TECHNICAL SERVICE BULLETIN

BCS Power Units (inc. CAMON Rotavators)

Handlebar Upgrade

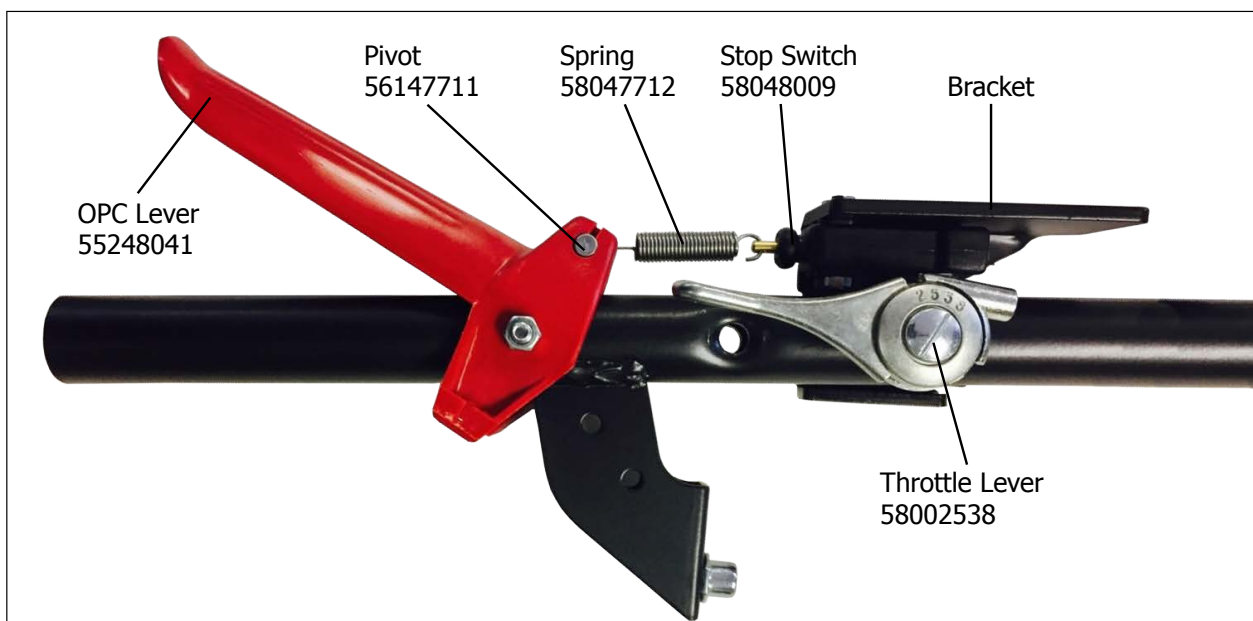
1. Remove the OPC lever, throttle, and stop switch from the old handlebars. Keep the fixings as they will be required to refit the items to the new handlebars.
2. Refit the OPC lever onto the first hole on the new handlebar using the previously removed fixings.
3. Fit the black stop switch to the underside of the bracket that was supplied with the new handlebar.
4. Bolt the bracket into the third hole using the throttle lever on the inside of the handlebar.
5. Refit the remaining parts as shown below.
